RNTPC Paper No. A/YL-LFS/447
For Consideration by the
Rural and New Town Planning
Committee on 3.2.2023

APPLICATION NO. A/YL-LFS/447

- Applicant** : Mr. Tang Kin Ting represented by FiBi International Project Consultancy Co. Limited
- Site** : Lot 1169 in D.D.129, Mong Tseng Wai, Lau Fau Shan, Yuen Long, New Territories
- Site Area** : About 2,355m²
- Lease** : Block Government Lease (demised for agricultural use)
- Plan** : Approved Lau Fau Shan and Tsim Bei Tsui Outline Zoning Plan (OZP) No. S/YL-LFS/11
- Zoning** : “Village Type Development” (“V”)
- Application** : Proposed Filling of Pond for Permitted Agricultural Use

Figure 1 Some pipe works (marked in red) surrounding the application site would be proposed for drainage purpose

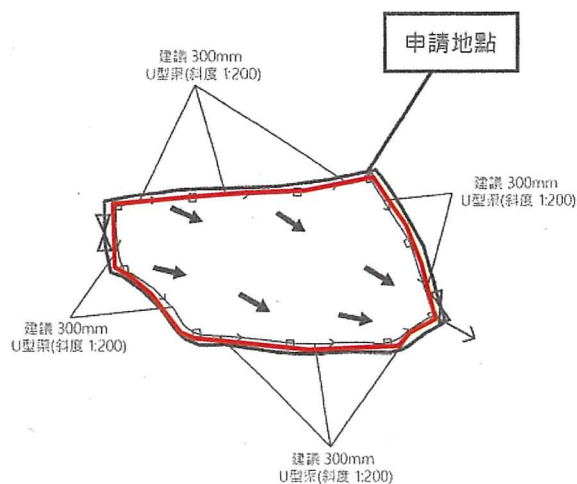
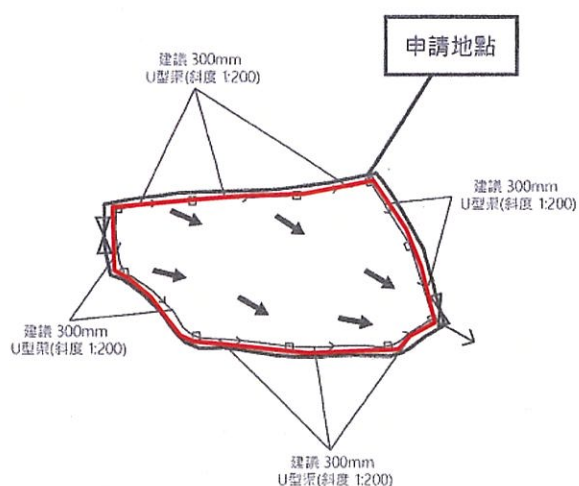
proposed for drainage purpose (Figure 1). However, we cannot see associated works such as land excavation has been mentioned in the application. Meanwhile, Drawing 4 did not mention what specific use or works would be proposed in the area just next to the area for agricultural purpose (Figure 2). We worry that all the above would cause both direct and indirect environmental impacts in the application site and its surrounding area.

- Potential impact brought by additional works: From Drawing 2, we would assume that some pipe works surrounding the application site would be proposed for drainage purpose (Figure 1). However, we cannot see associated works such as land excavation has been mentioned in the application. We worry that all the above would cause both direct and indirect environmental impacts in the application site and its surrounding area.
- Potential wastewater discharge during operation phase: With reference to Stormwater Drainage Design provided by the applicant, existing drainage outlet and outfall would be formed in the south of the application site. We are concerned about that wastewater accumulated, mostly from sewage effluent in adjacent village settlements, would end up in discharging into those fish ponds within the Wetland Conservation Area.

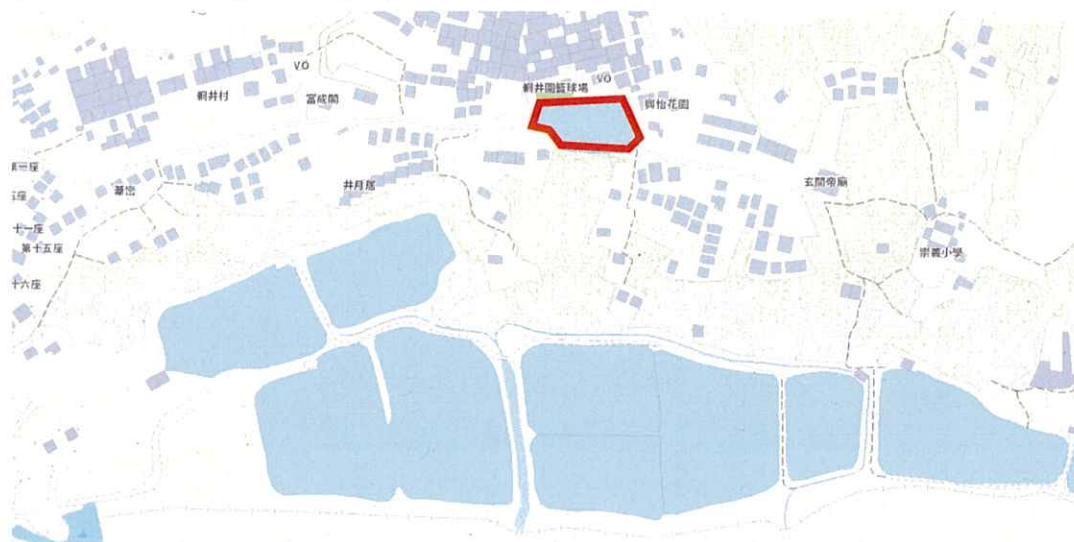
- 1.3 From the map extracted from GeoInfo Map, there are still ponds and wetlands at and near the application site (Figure 1), forming a part of the Deep Bay wetland system. However, the proposed pond filling will lead to a loss in wetland which is not in line with the above planning intention of WBA to protect the ecological integrity of WCA and restore lost wetlands. We urge the Town Planning Board (Board) to reject this application.

繪圖 DRAWING
A-1

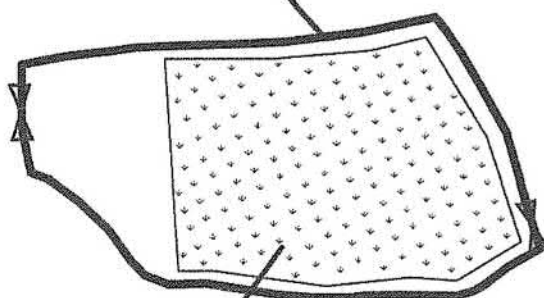
- (c) no detail on the proposed agricultural use, such as crop variety, farming methods, farm operation and management and water source is provided in the submission. Also, no detail is provided as to how the area to the west of the proposed agricultural area as shown on the agriculture layout plan (**Drawing A-2**) would be used. There is doubt on whether the Site would be genuinely used for agricultural use upon pond filling;

As shown on the agriculture layout plan at Drawing A-2, about 1,435m² (or 61%) of the Site would be used for agricultural use. No information on the agricultural use to be carried out at the Site, as well as the use of the remaining area of the Site (about 920m² or 39%) has been provided in the submission

繪圖 DRAWING
A-4

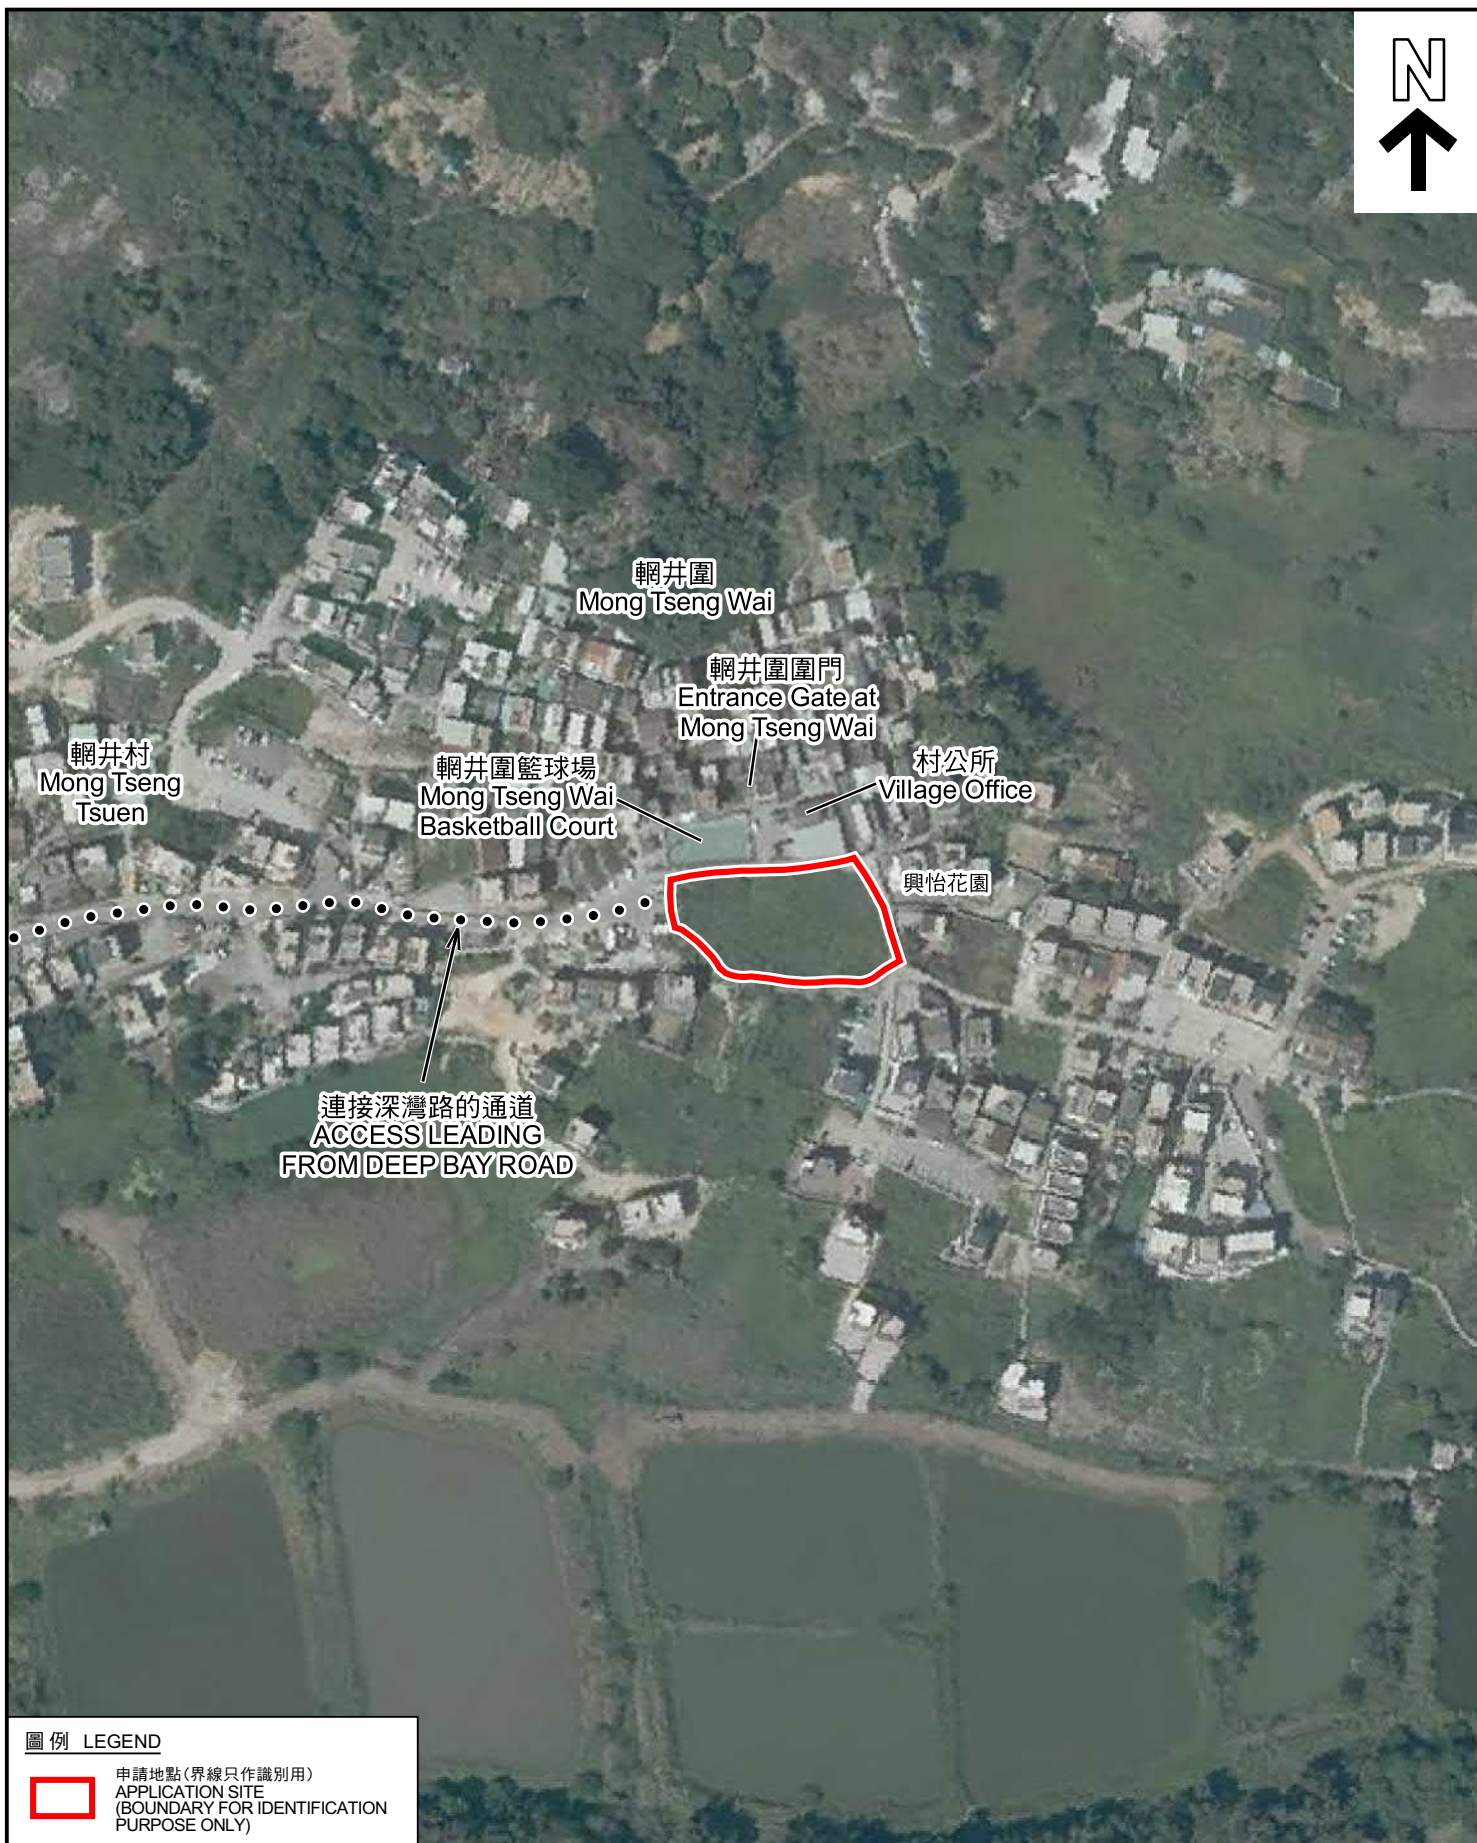
- (a) There are a number of village drains discharging to the pond which is proposed to be filled. In the FI received on 7.12.2022, although the applicant proposed to provide a 1.0m (width) × 0.5m (depth) concrete channel to intercept the overland flow, the diversion to the existing connected channel/drains currently discharging to the pond is unclear. The applicant is required to demonstrate the existing drains, which are now discharging to the pond, are properly diverted to maintain their function after the proposed pond filling.
- (b) Since the pond acts as a retention facility, the discharge characteristic of the pond would be different after the proposed pond filling. The applicant is also required to demonstrate that the downstream capacity of the existing drainage system will have sufficient capacity to cater for the additional flow.

Comment	Response
The Applicant is required to firstly provide diversion proposal to the existing discharge.	See attachment “Existing Drainage Diversion Proposal (MTD02)” & Proposed Drainage Layout (MTW/SK002).
, and secondly, assess the effect to the area after the pond is filled.	See attachment “Existing Drainage Diversion Proposal (MTD02)” & Proposed Drainage Layout (MTW/SK002).
